### The Corporation of the Town of Milton Committee of Adjustment and Consent

Thursday, January 30, 2025, 6:00 p.m. Council Chambers - In Person

Committee of Adjustment Minutes

Figure 1 - Proposed Internal Garage Configuration

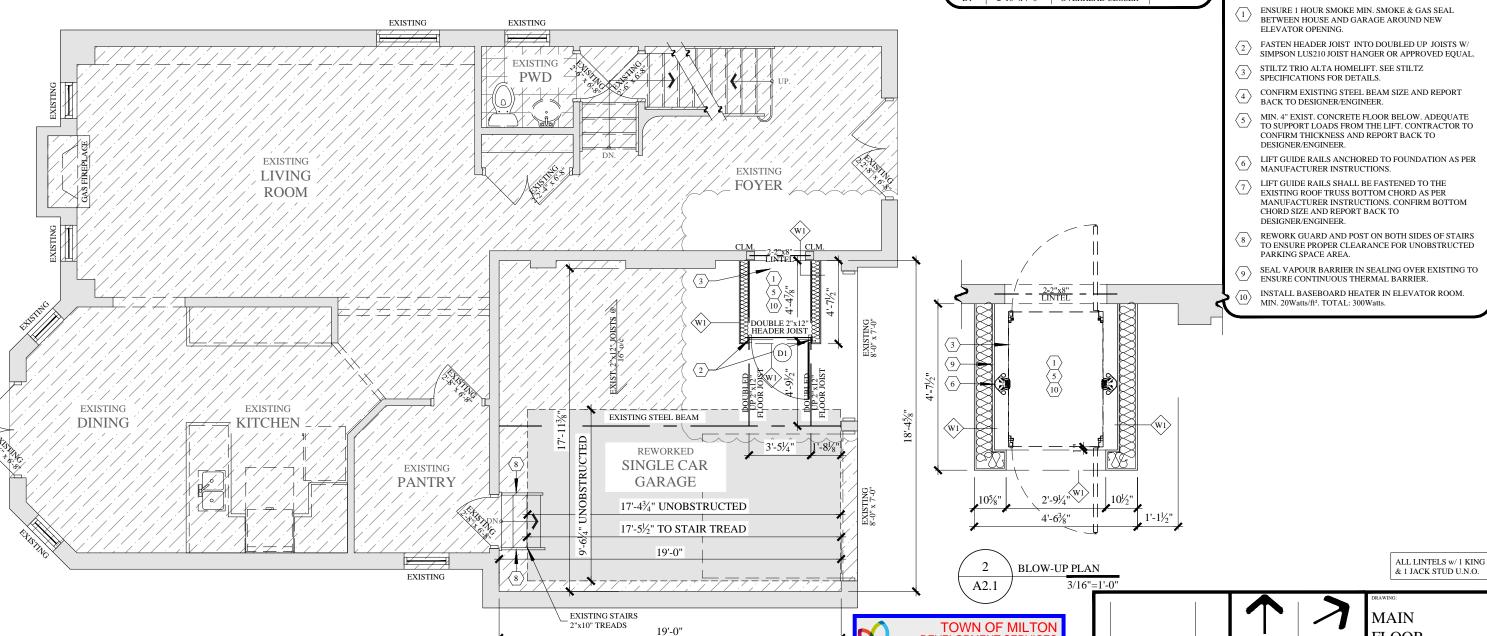
The applicant intends to construct an elevator lift within the existing garage to accommodate an accessible access to the second floor of the detached dwelling. The proposed accessibility feature would be located within the garage - as a result, one of two internal parking spaces would be eliminated.

While the installation of the elevator would eliminate one parking space and alter the technical dimensions of a double car garage, Planning Staff are of the opinion that it is minor in nature and will not impact the principal use of the property. Three parking spaces (one in the garage and two on the driveway) would be provided which satisfies the zone provisions related to a single detached dwelling and provides flexibility to the owner in future if they intend to pursue an accessory use that requires additional parking spaces beyond those required for the principal dwelling (i.e. home occupation or short-term rental). Further, given the property has sufficient parking for the existing use (and potential accessory uses in the future), there is no anticipated

Recommendation: THAT the application for minor variance BE APPROVED SUBJECT TO

1. The a Building Permit be issued from two (2) years from the date of decision: and.

Figure 1 - Proposed Site Plan

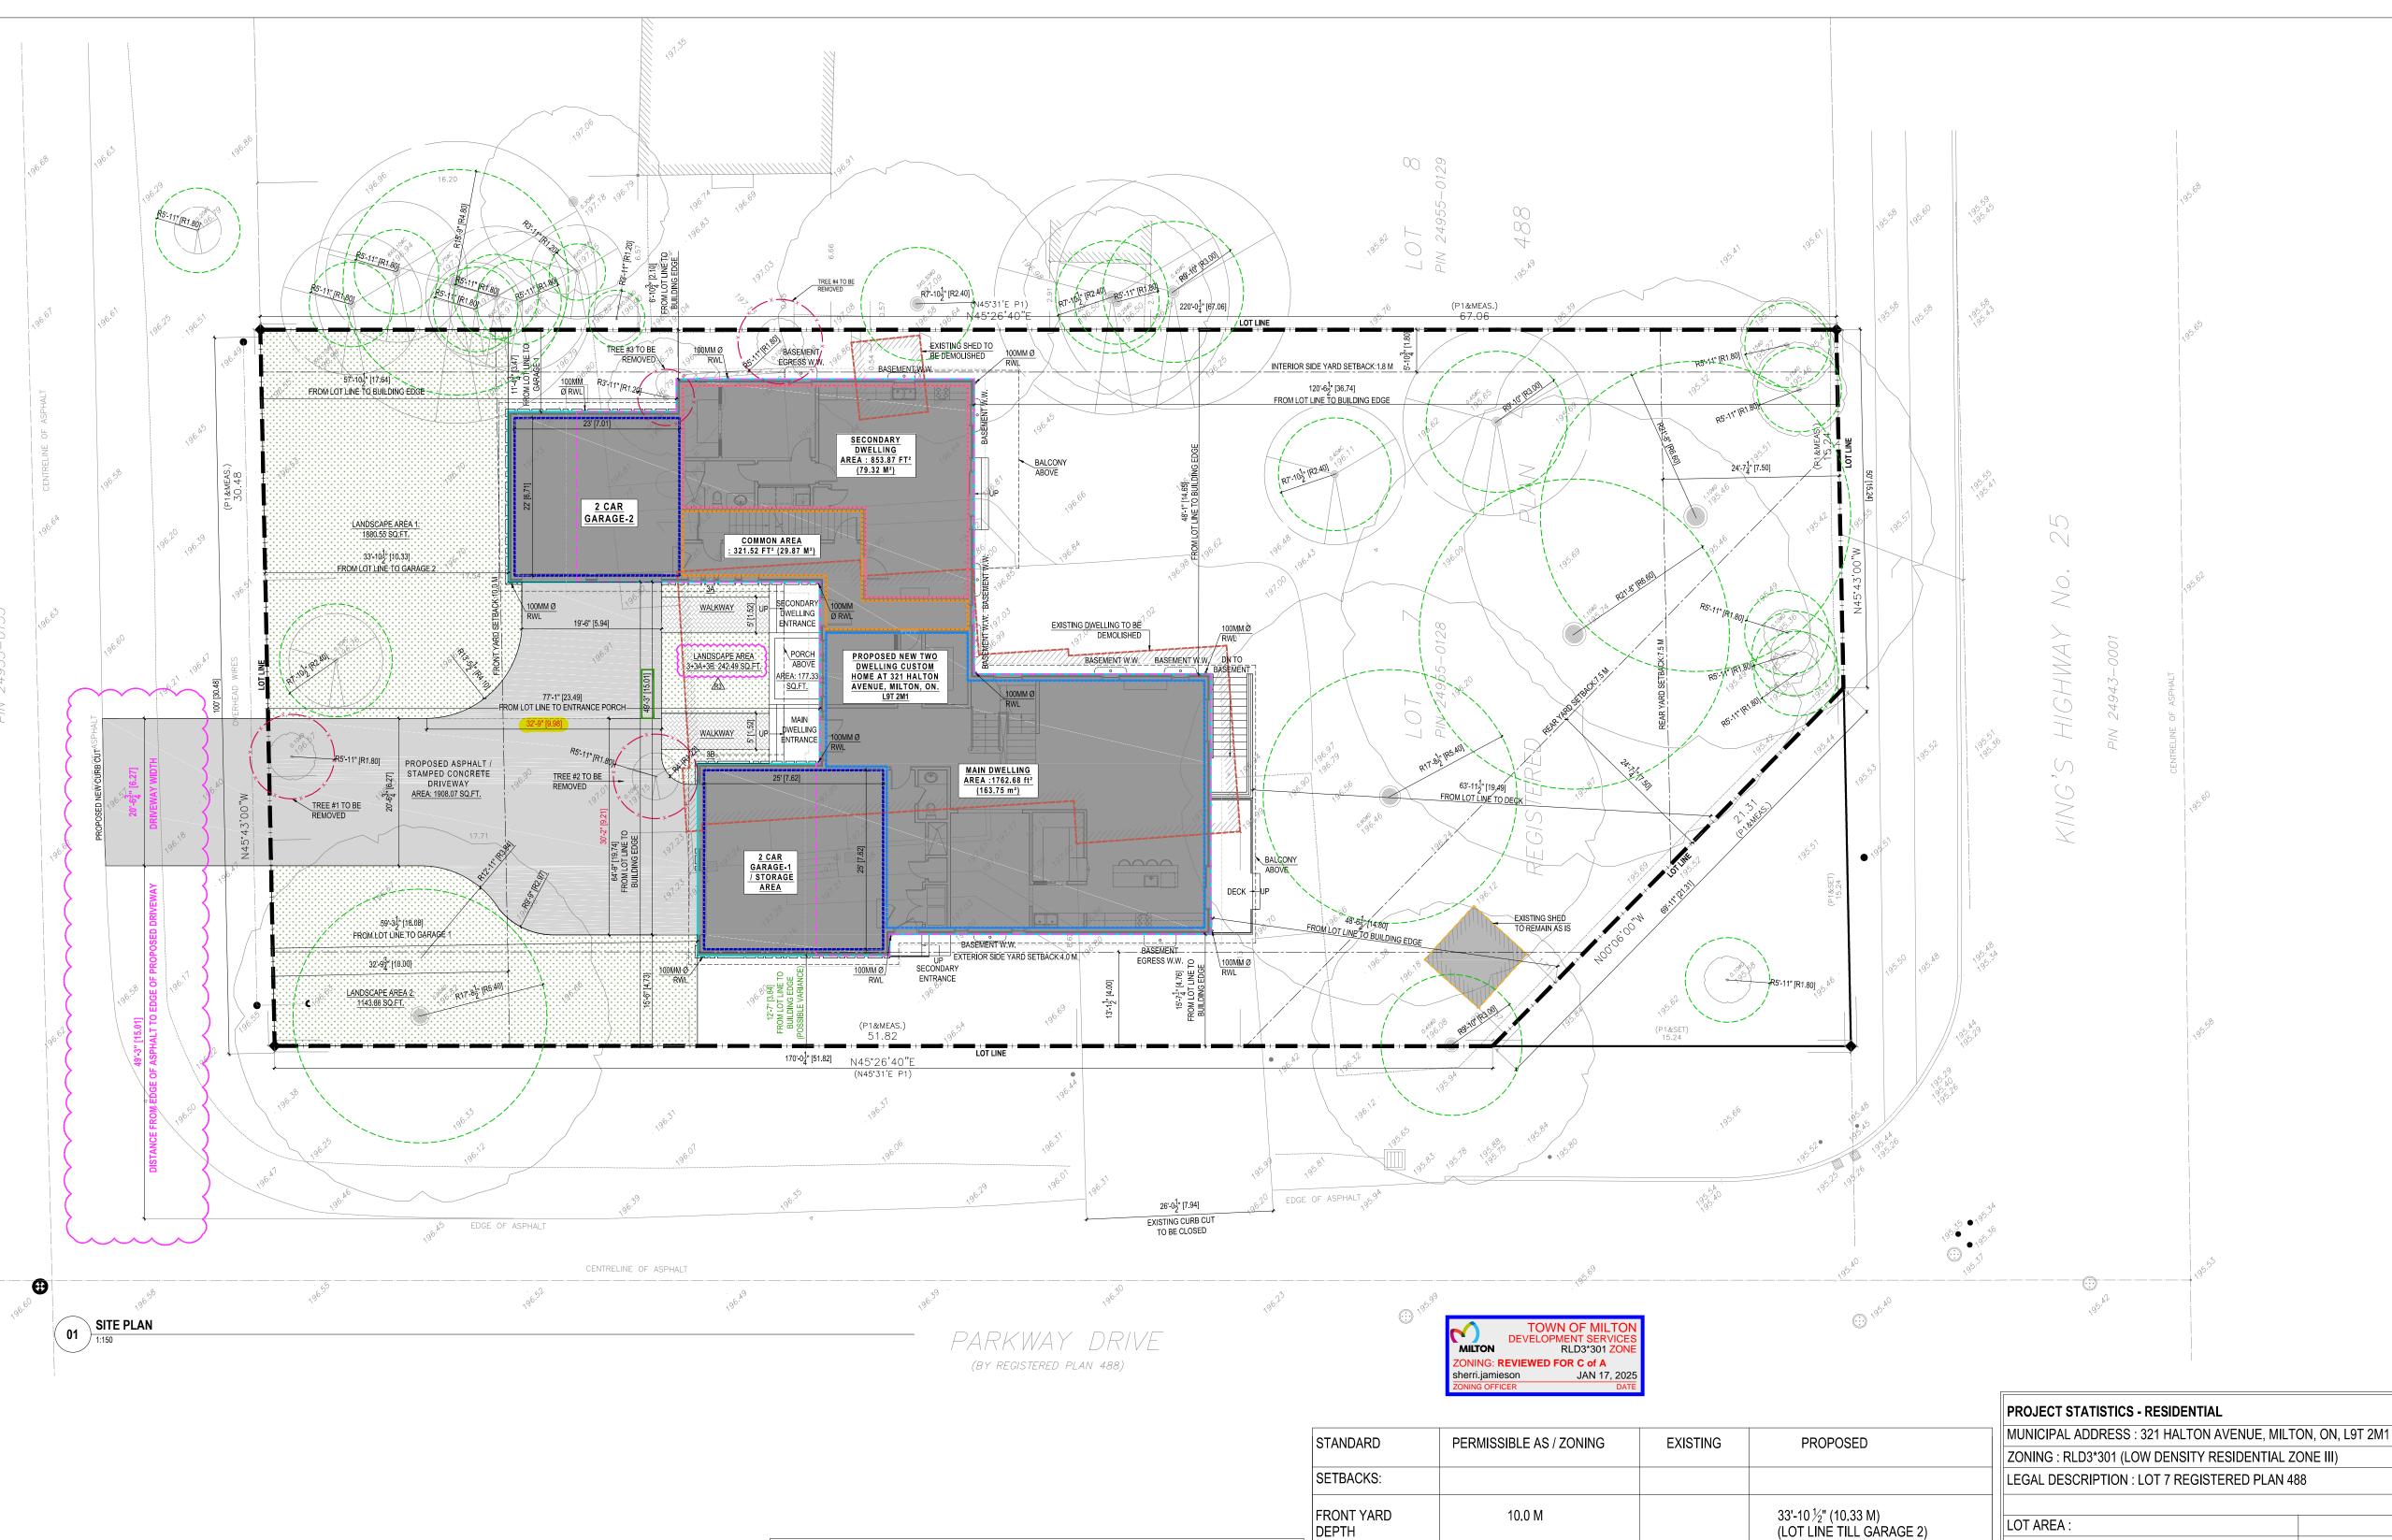
Section 5.6.2 iv. d) e) of the Zoning By-law permits a maximum driveway width of 8.0 metres for lots that have a frontage greater than 11.5 metres. To accommodate the proposed driveway and width (see Figure 1 - Proposed Site Plan for driveway measurements), the applicant is seeking relief from the above-noted provision to allow for a 9.98 metre driveway width. The intent of this provision is to ensure that the driveway does not result in negative drainage impacts (related to impervious surface), is not the dominant feature of the development and does not minimize landscaped area/open space.

Staff acknowledge that the original request related to the driveway was to allow a 15.01 metre width. The applicant revised the Site Plan to provide additional landscaped area in order to reduce the driveway width and mitigate concerns related to the extent of relief being requested.

The original site plan provided showed the proposed drive located 14 metres from the Halton Avenue and Parkway Drive intersection. Transportation Staff confirmed that the Transportation Association of Canada standards require a minimum of 15 metres. The applicant revised the site plan to accommodate the required 15 metres and as part of the recommendation from Planning Staff, a condition has been proposed that requires the development - including the driveway siting - to be in accordance with the updated site plan attached as Figure 1 to this report.

The curb cut being proposed is 8 metres as the increase in width is located solely at the garage accesses - Development Engineering is satisfied with this as the 8 metre curb cut is in compliance with the Town's Engineering and Parks Standards Manual. There were no concerns raised related to drainage or the added impervious surface.

From a planning perspective, the driveway will not be the dominate feature of the development and the applicant has incorporated landscape features to minimize the impact of the driveway itself. The overall effect of the added width is minimal given the size of the lot and configuration of the proposed driveway. As such, Planning Staff offer no objection.

That the development, including the driveway, proceed in accordance with the site plan and elevations, prepared by Technoarch Architects and Designers, dated stamped by Town Zoning on January 17, 2025;

2. That prior to Building Permit issuance, the applicant provide a Stormwater Management Brief and Grading Plan, to the satisfaction of Town Development Engineering Staff:

Figure 1 - Proposed Site Plan

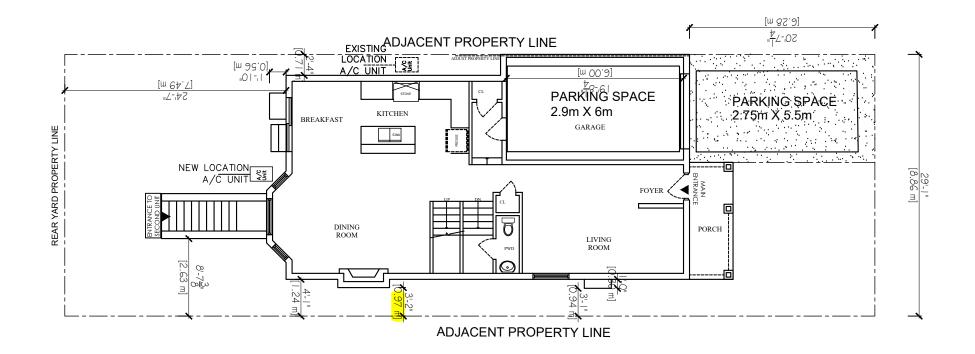
The dwelling has an existing chimney located in the side yard where the unobstructed pedestrian access is proposed and therefore requires relief from provision Section 4.10 vii) given a chimney is not a permitted encroachment.

Milton Fire is supportive of the application subject to a residential sprinkler system being installed within the ARU. The intent of this is to mitigate any impact associated with the proposed obstruction being located within the pedestrian access. By providing fire suppression measures such as a sprinkler system, this will allow firefighters additional response time when accessing the unit if the obstruction slightly delays access.

While the chimney does encroach into the required unobstructed pedestrian access, it does not extend along the full length of the access but rather projects at one specific point. The remainder of the access is in compliance with the Zoning By-law. Further, the obstruction projects 0.23 metres therefore providing a 0.97 metre access at the pinch point created by the chimney.

It is Planning Staff's opinion that the encroachment does not render the unobstructed pedestrian access inadequate and it can function as intended, subject to a residential sprinkler system being installed within the ARU. While the pedestrian access provides a path of travel to and from the unit, the fire suppression measure will aid in mitigating any delay in accessing the unit that may be caused by the proposed obstruction and does not jeopardize the safety of the unit nor its tenants.

That the development and unobstructed pedestrian access shall be constructed and provided in accordance with the site plan prepared by Out of the Box Engineering Inc., dated stamped by Town Zoning on December 5, 2024;

- That the approved Building Permit drawings for the Additional Residential Unit include a residential sprinkler system within the unit;
- 3. That a Building Permit be obtained within two (2) years from the date of decision; and,
- 4. The approval be subject to an expiry of two (2) years from the date of the decision if the conditions are not met, if the proposed development does not proceed and/or a Building Permit is not secured.

Figure 1 - Proposed Site Plan

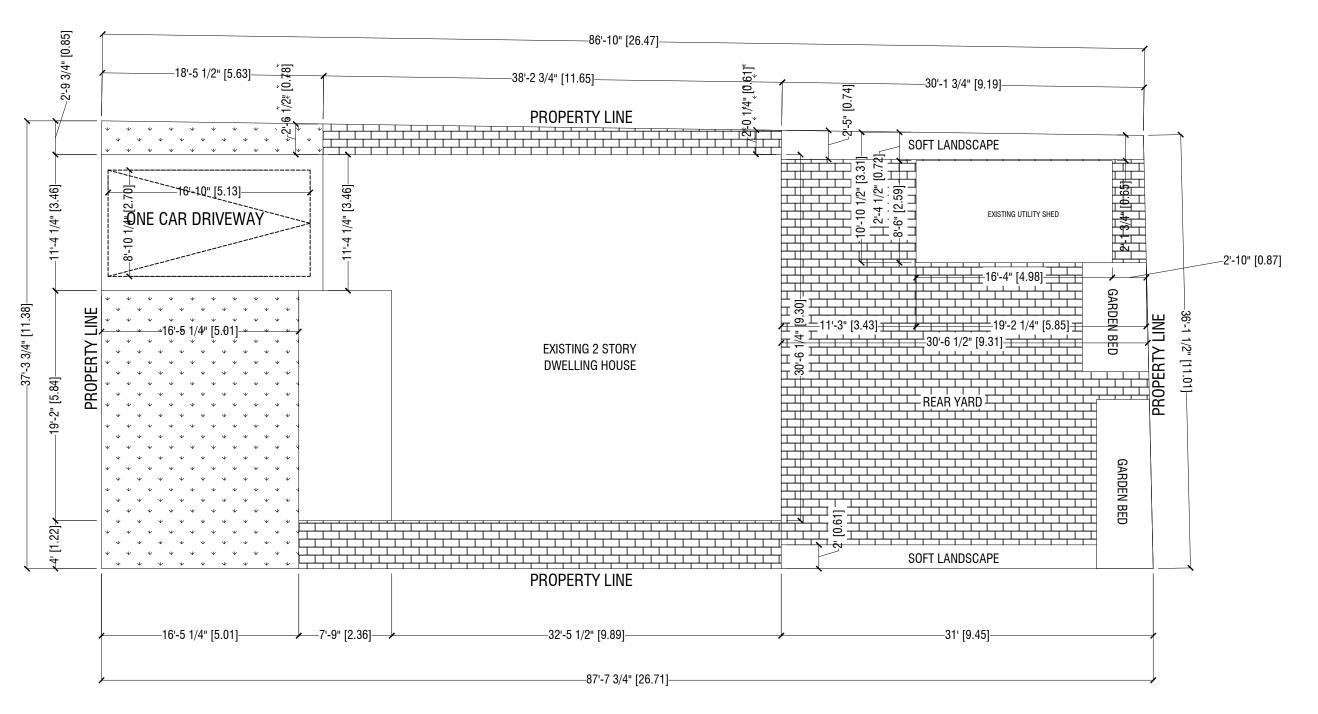
Planning Staff received a concern from an adjacent property owner regarding visual impact of the structure. Staff acknowledge that should the applicant want to comply with the gross floor area provisions currently within the Zoning By-law, the visual impact of the structure is unlikely to change from what currently exists (given the structure already complies with height and setback provisions). However, in an effort to minimize visual impact, the applicant has agreed to include enhanced landscaping along the rear lot line - Planning Staff have included this as a condition of approval.

In an effort to mitigate any negative stormwater management and run-off concerns associated with the additional gross floor area, along with the existing hardscaping, the applicant has agreed to remove a 0.6 metre strip of hardscaping adjacent to the lot limits in the rear yard and reinstate it with permeable material (i.e. river stone, grass or granular materials). A condition of approval has been recommended to ensure that the works are completed in accordance with the proposed site plan that is attached as Figure 1 to this report.

The garden shed is located in the rear yard and with the exception of the proposed gross floor area, maintains all other zoning provisions, including height and setbacks. It is Planning Staff's opinion that the additional 2.89 square metres being requested is minor and negligible beyond any impact that the structure would have if it otherwise was constructed as-of-right.

1. That a 0.6 metre permeable surface be instated (and hardscaping removed) along the lot lines in the rear yard in accordance with the Site Plan dated January 7, 2025;

- 2. That enhanced landscaping be provided, to the satisfaction of Planning Staff, along the rear lot line; and,
- 3. That the decision be subject to an expiry of two (2) years if the conditions are not met and/or the development does not proceed.
